ISSUE: Certificate of Appropriateness for alterations

APPLICANT: Trustee of St. Paul's Episcopal Church

LOCATION: Old and Historic Alexandria District
228 South Pitt Street

The applicant is requesting a Certificate of Appropriateness for rooftop screening of new HVAC equipment on the Wilmer Hall, at 228 South Pitt Street. The proposed screening will be standing seam metal and nine feet in height. It will match the existing rooftop screening approved by the Board on June 7, 2006 (BAR2006-00053).

VIEW PLAN

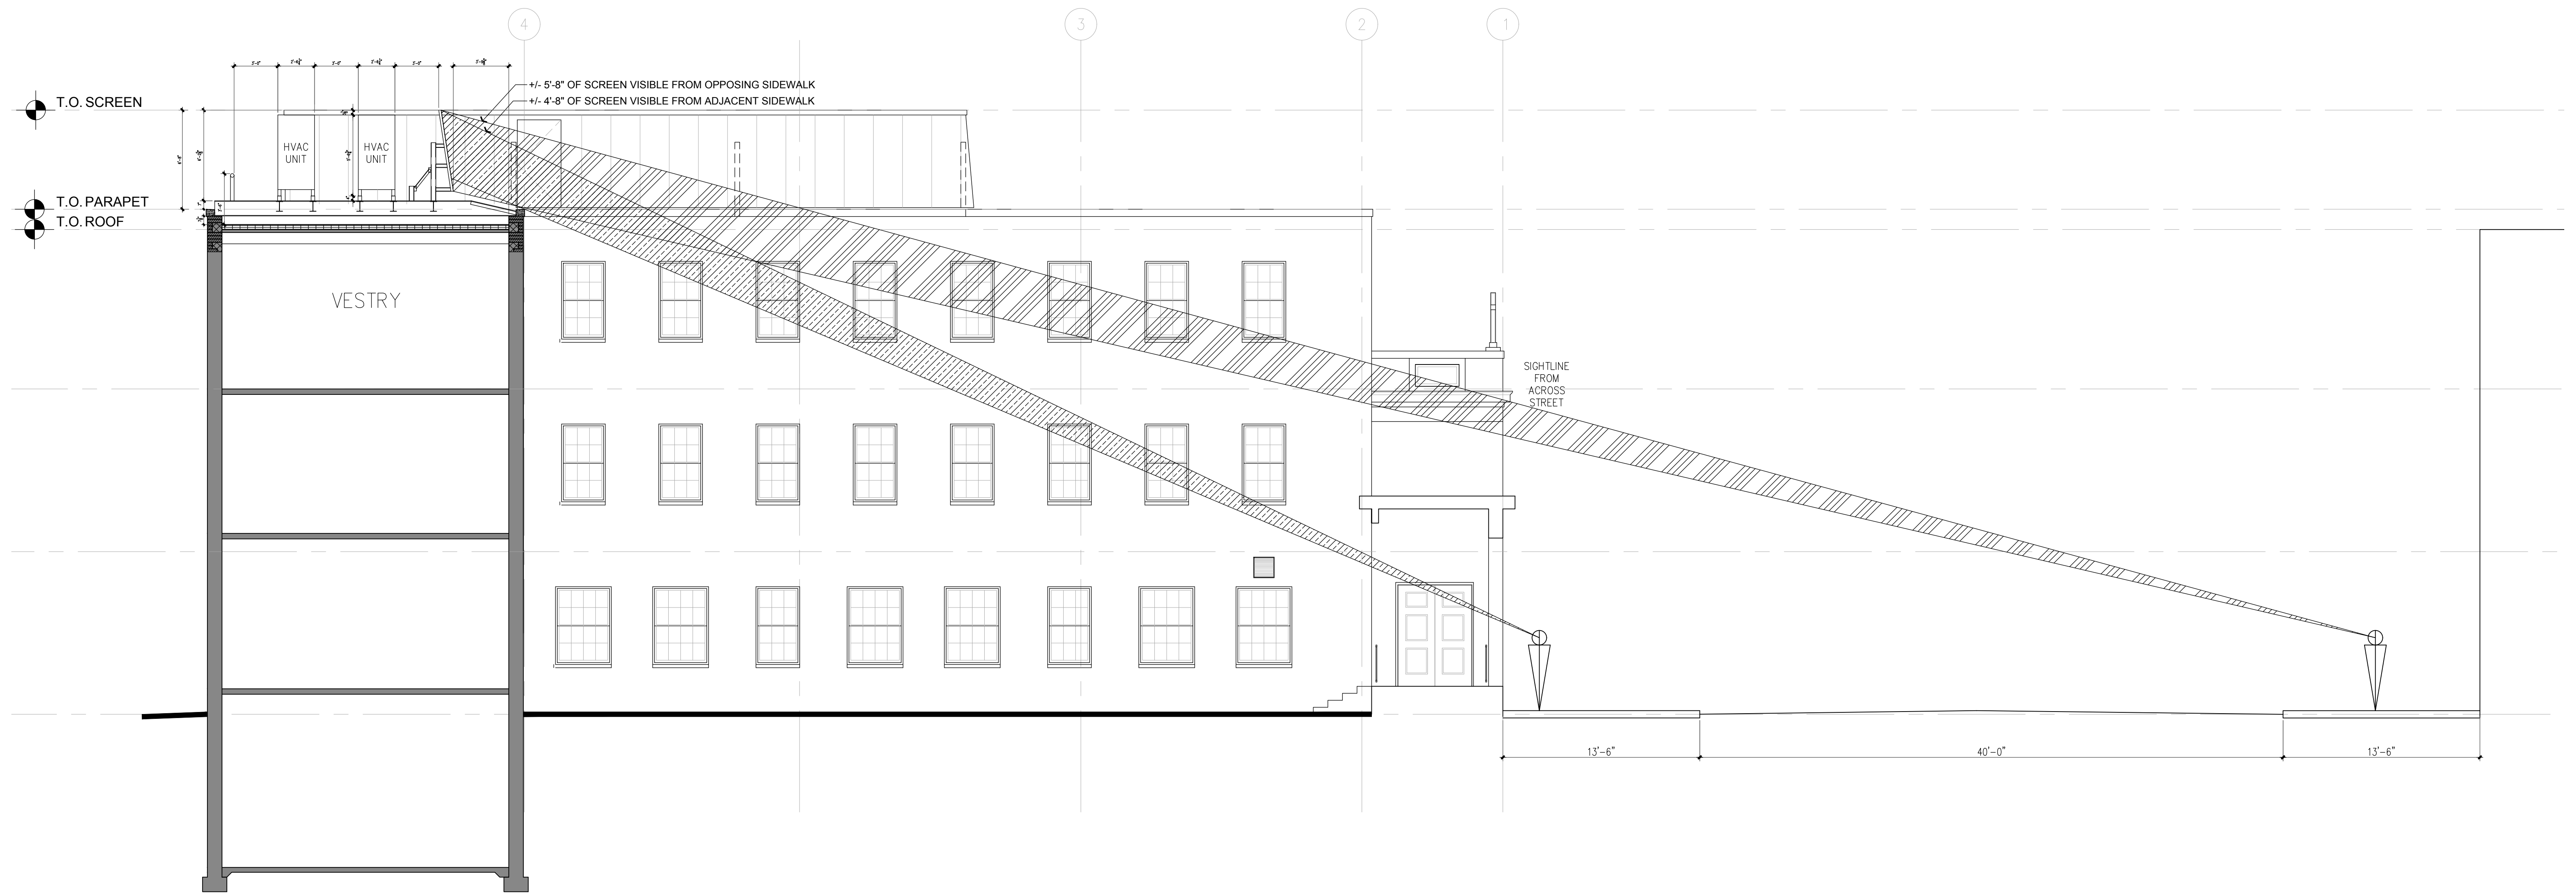
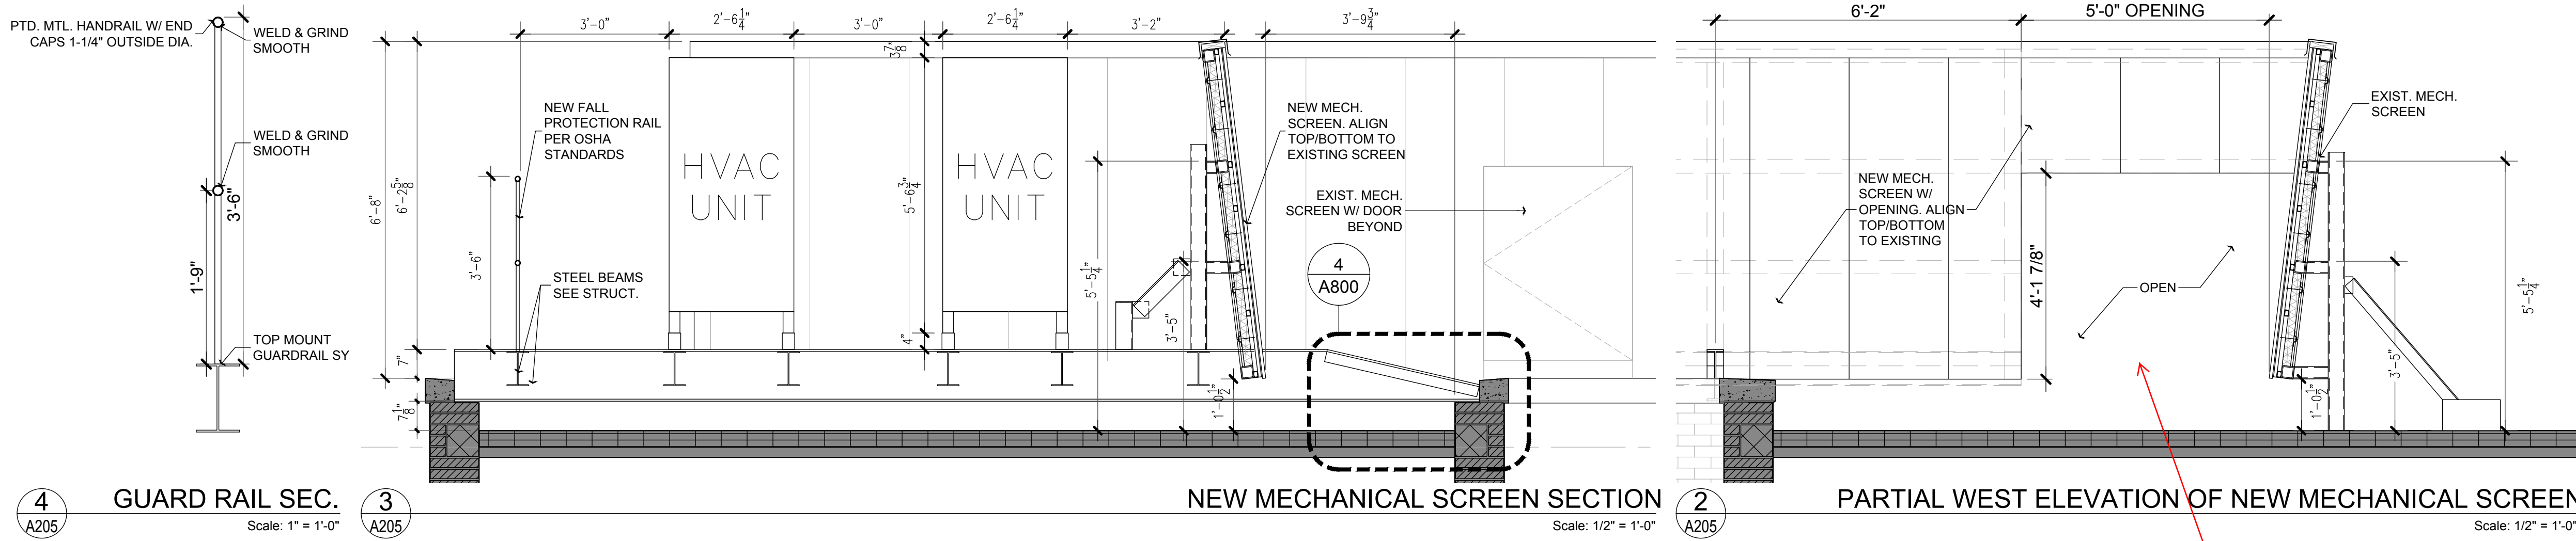
Based on the very helpful photographic mockups and sight studies from South Pitt Street provided by the applicant, staff believes that screening on the west elevation is far preferable to no screening, given the size and number of the mechanical units and their location immediately adjacent to the oft photographed historic sanctuary. Screening is not being provided on the east side of the roof, as it is internal to the site and is not visible from a public way. Working with staff, the applicant has consolidated the units at the south end of this roof area to keep them as far as possible from the historic sanctuary, joined the new screening with the exiting rooftop screening to the south and returned the screen wall several feet on the north end to give it some visual mass.

In this case, staff does not believe the use of screening that is more closely related to the material and style of the building, such as brick or stucco, would be a good solution here. Given the height and size of the proposed screening, a brick or stucco wall may be perceived as a fourth story of the building and masonry would be very heavy and difficult for the existing roof structure to support. The proposed standing seam metal screening will not read as an additional building story, is high quality, matches the existing adjacent screening and the light gray color will generally recede against the sky.

Staff recommends approval of the Certificate of Appropriateness, as submitted.
